Subject: **Revised Permit Modification Request for the Section 404 Individual Permit, Section 401 Individual Water Quality Certification and CAMA Major Development Permit** for the proposed improvements to US 70 from existing four lanes at Radio Island to north of Olga Road (SR 1426), Carteret County, State Project No. 8.1162501, Federal Aid Project STPNHF-70(43), TIP R-3307, WBS 34528.1.1.

Please see the enclosed revised permit drawings and impact summary sheet for the above referenced project. This revised permit modification request provides changes requested by regulatory agencies as well as updates to the previous request dated November 20, 2015.

# Permit Drawing Sheet 3 of 34 Revised 16 Dec 2015

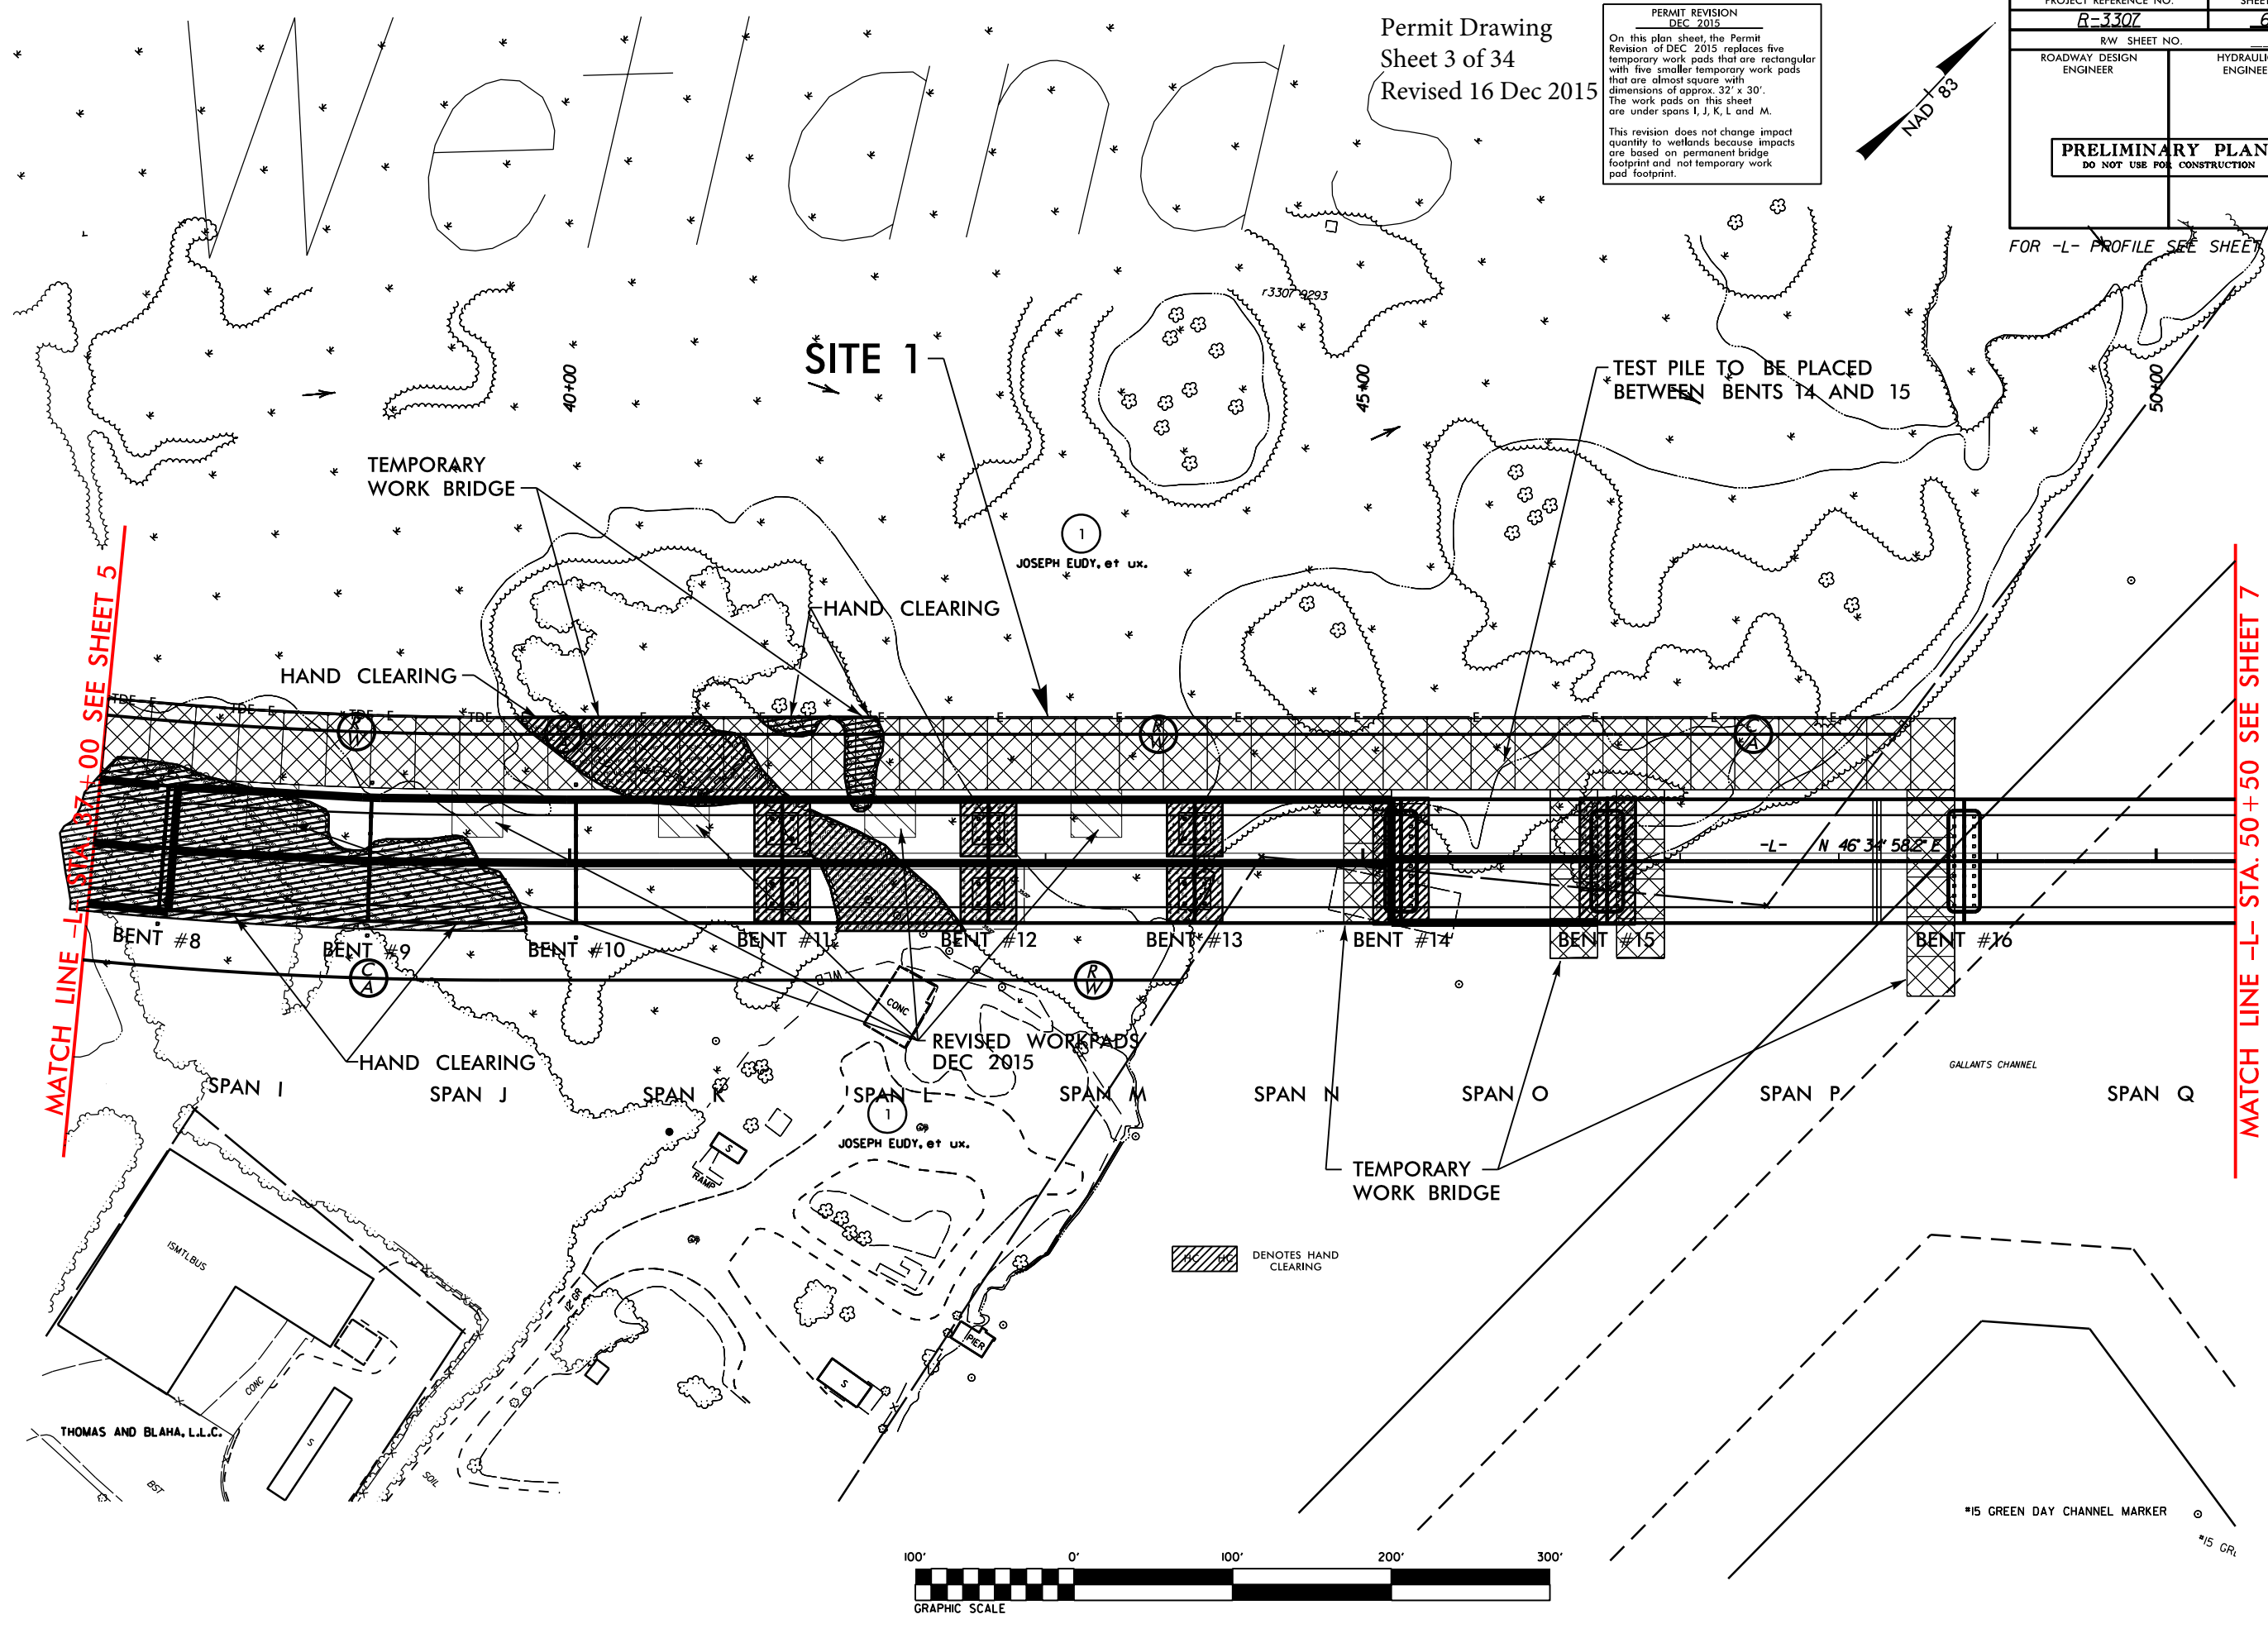
**PERMIT REVISION DEC 2015**

On this plan sheet, the Permit Revision of DEC 2015 replaces three temporary work pads that are rectangular with three smaller temporary work pads that are almost square with dimensions of approx. 32' x 30'. The work pads on this sheet are under spans F, G, and H.

This revision does not change impact quantity to wetlands because impacts are based on permanent bridge footprint and not temporary work pad footprint.

PROJECT REFERENCE NO.	SHEET NO.
R-3307	8
RW SHEET NO.	
ROADWAY DESIGN ENGINEER	HYDRAULICS ENGINEER
Permit Drawing	
Sheet 5 of 34	
Revised 16 Dec 2015

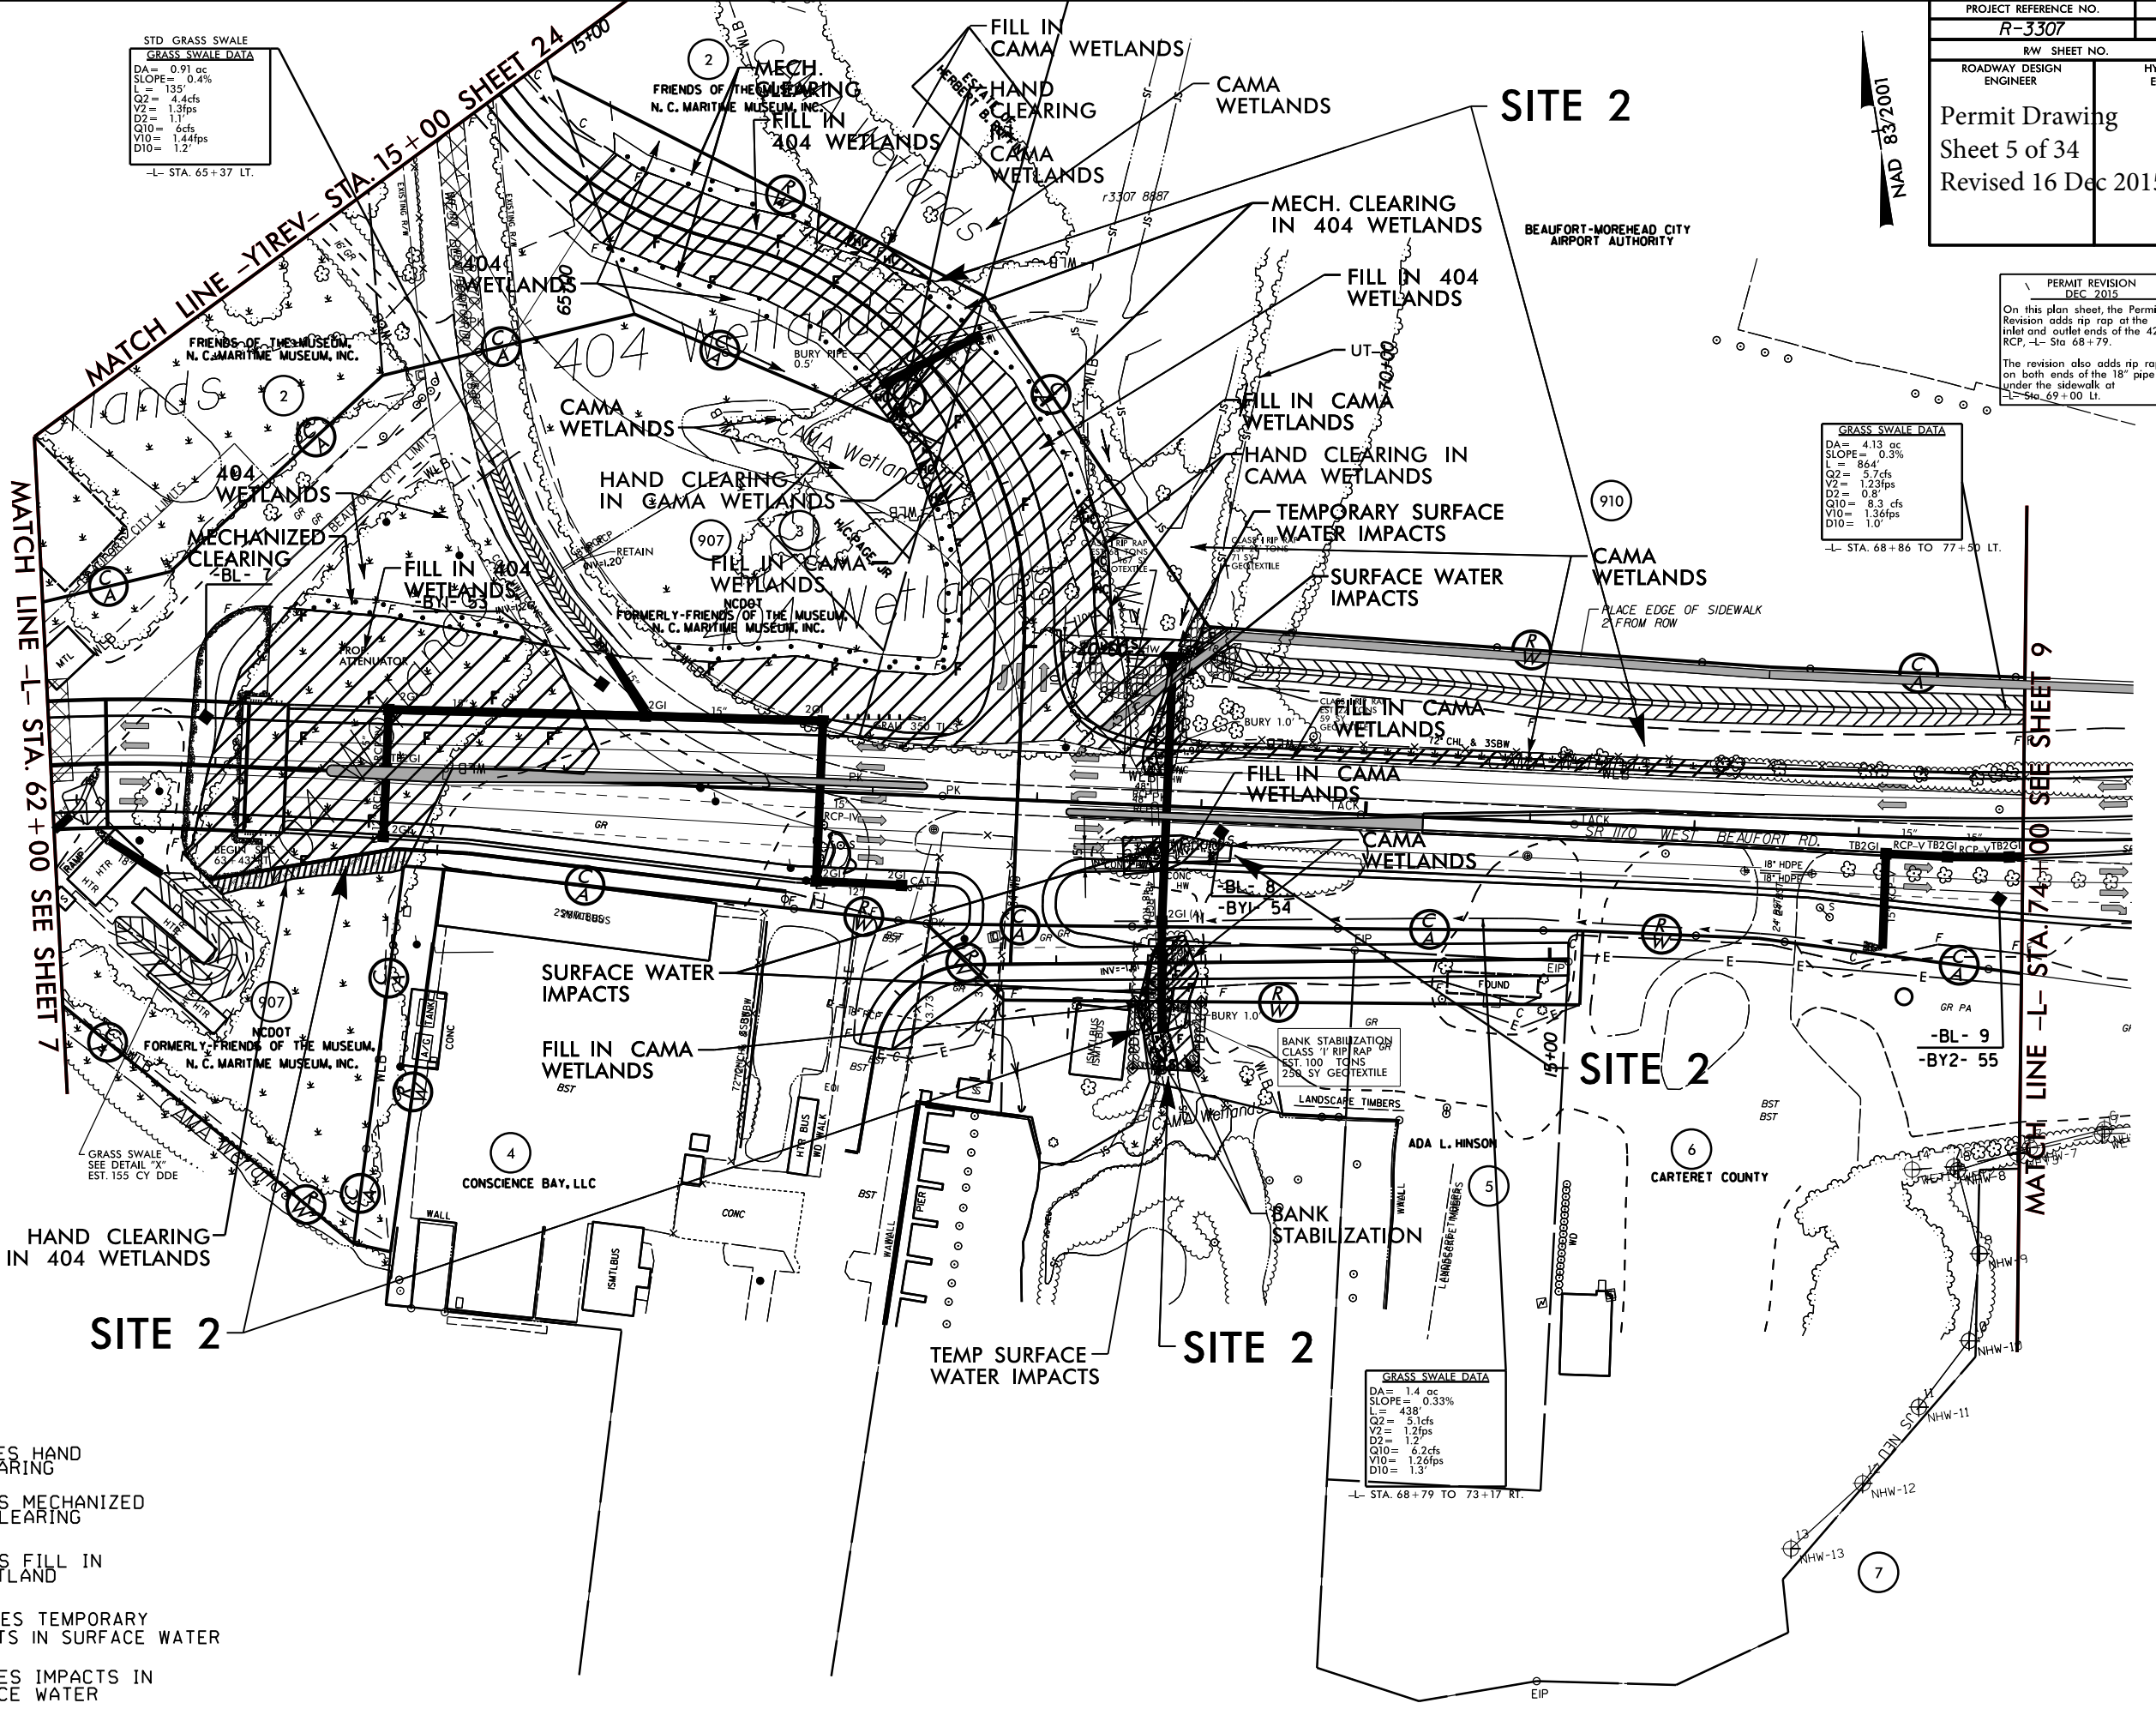
PERMIT REVISION  
DEC 2015  
On this plan sheet, the Permit Revision adds rip rap at the inlet and outlet ends of the 42" RCP, -L- Sta 68+79.  
The revision also adds rip rap on both ends of the 18" pipe under the sidewalk at -L- Sta 69+00 Lt.

PROJECT REFERENCE NO. R-3307	SHEET NO. 8
RW SHEET NO.	
ROADWAY DESIGN ENGINEER	HYDRAULICS ENGINEER
Permit Drawing Sheet 5a of 34 Revised 16 Dec 2015

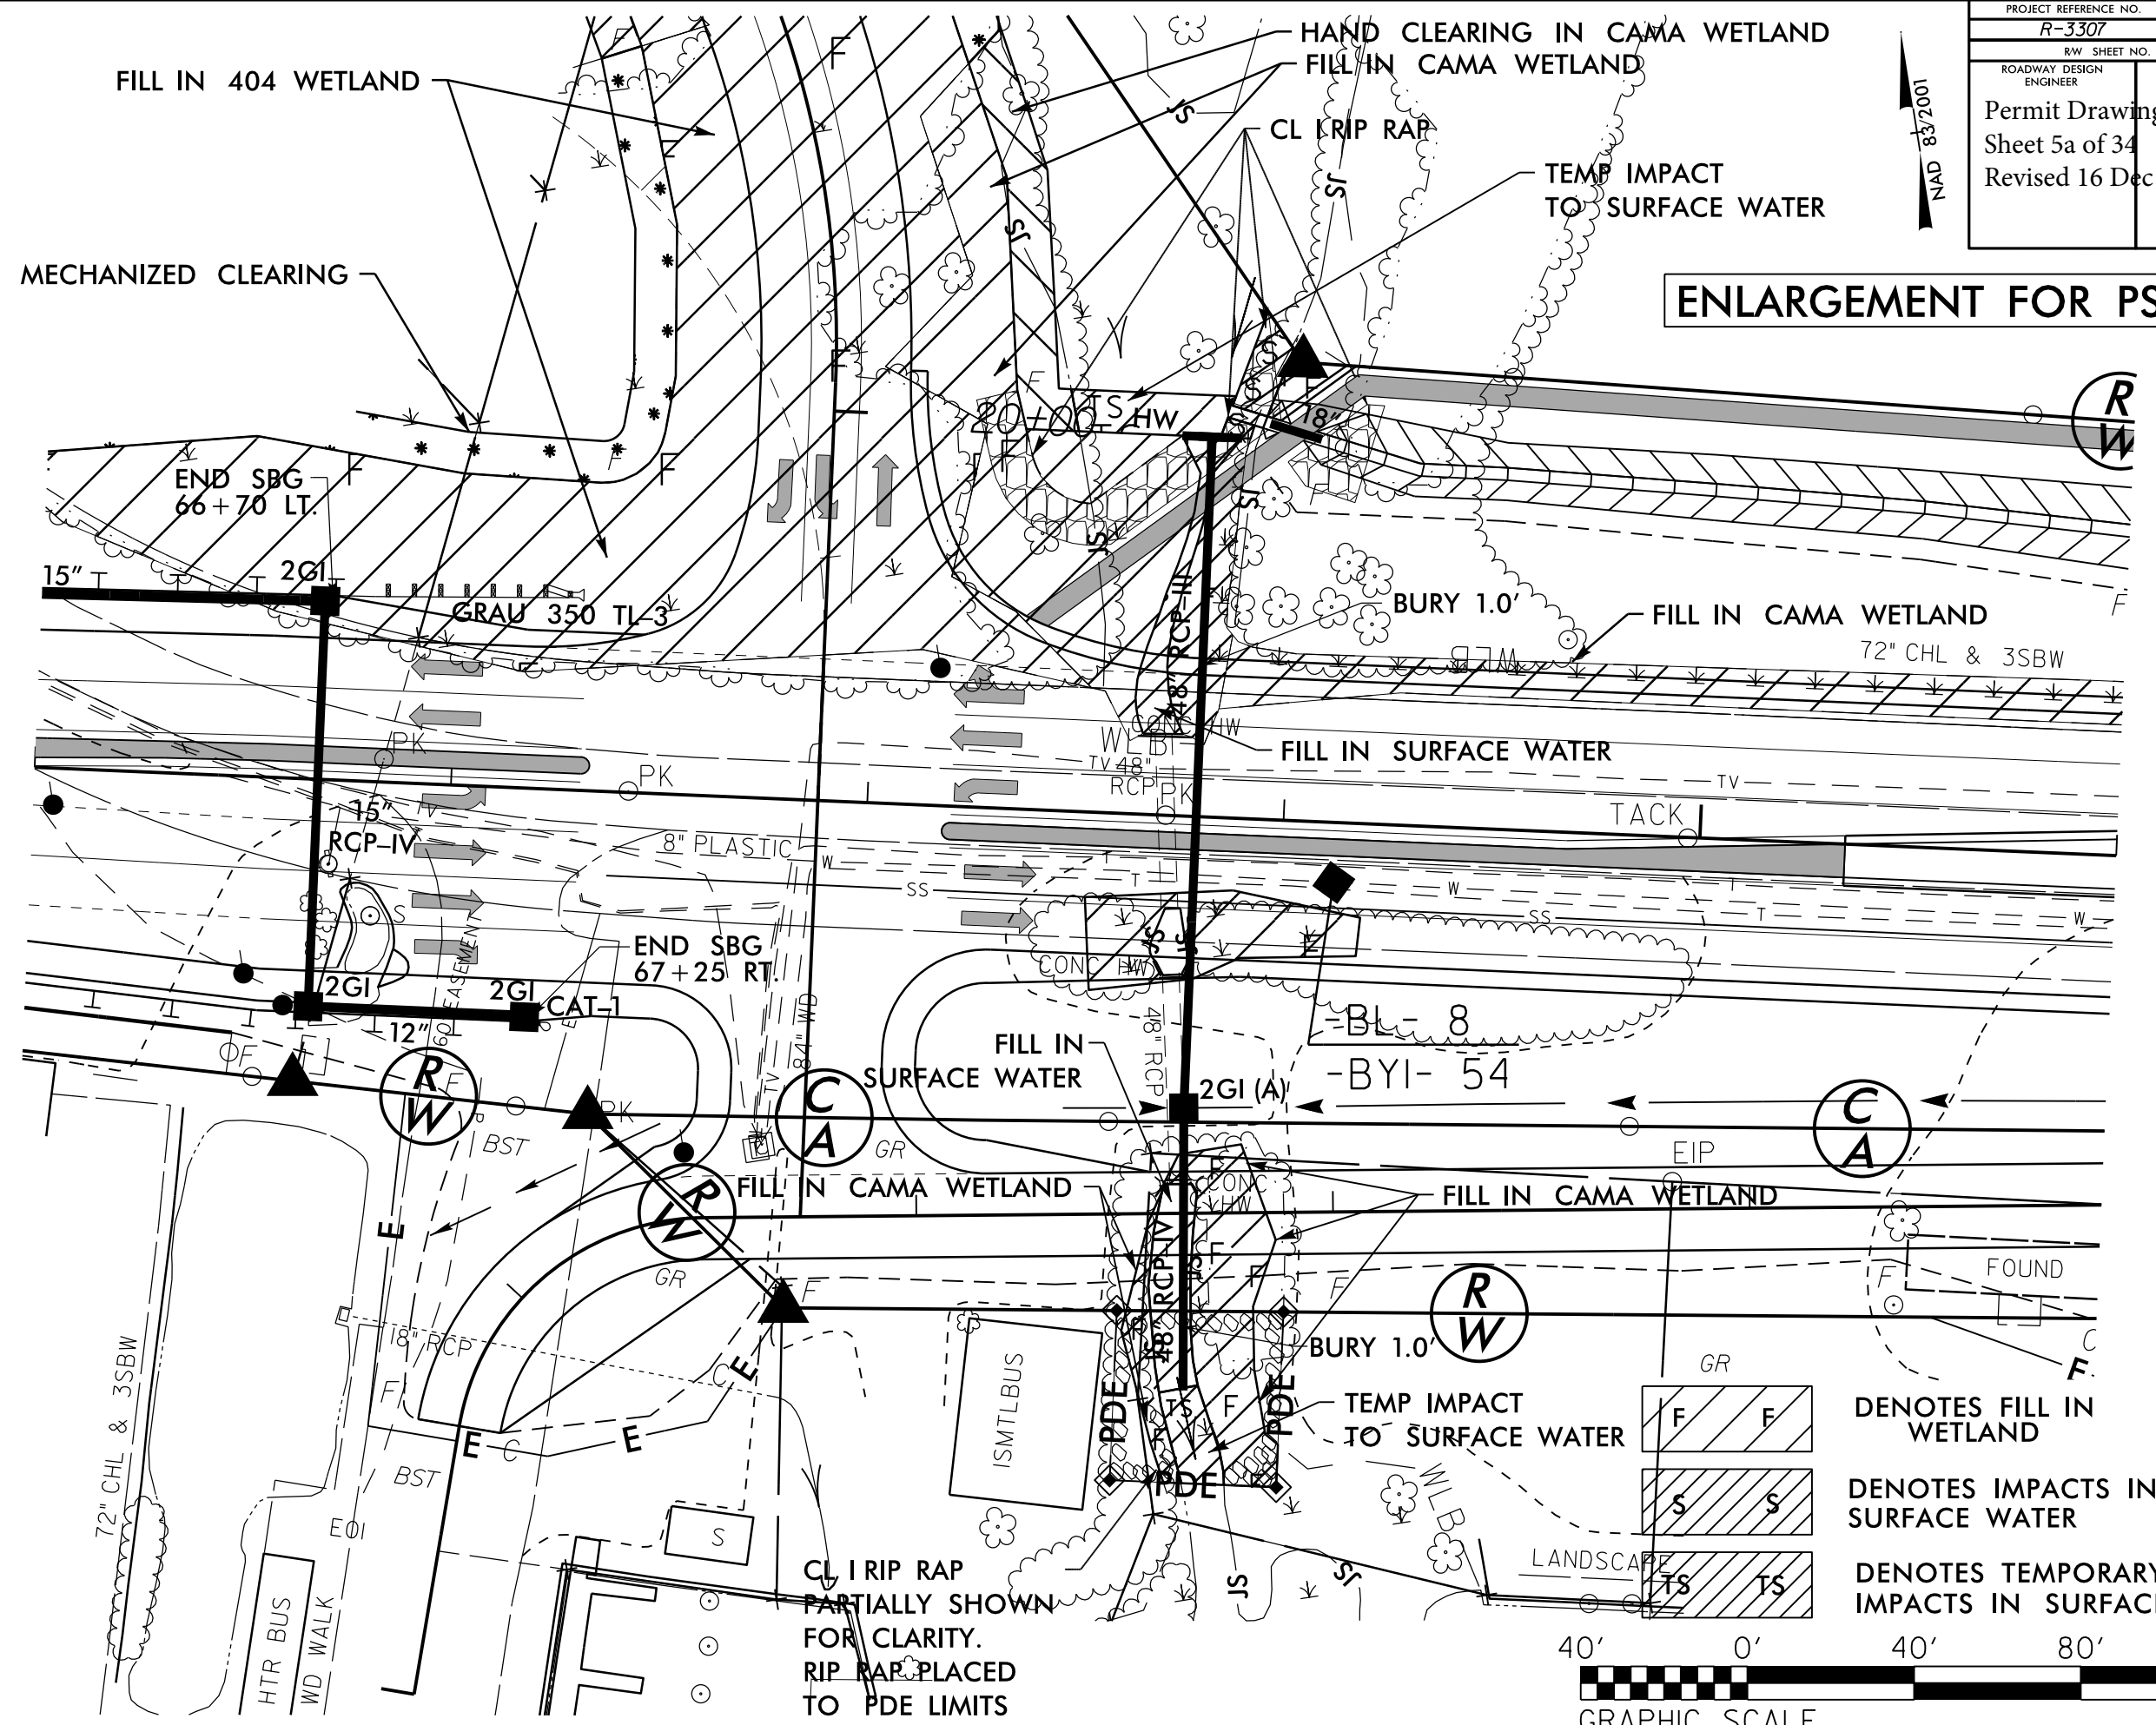
**ENLARGEMENT FOR PSH 8**

CL RIP RAP  
PARTIALLY SHOWN  
FOR CLARITY.  
RIP RAP PLACED  
TO PDE LIMITS
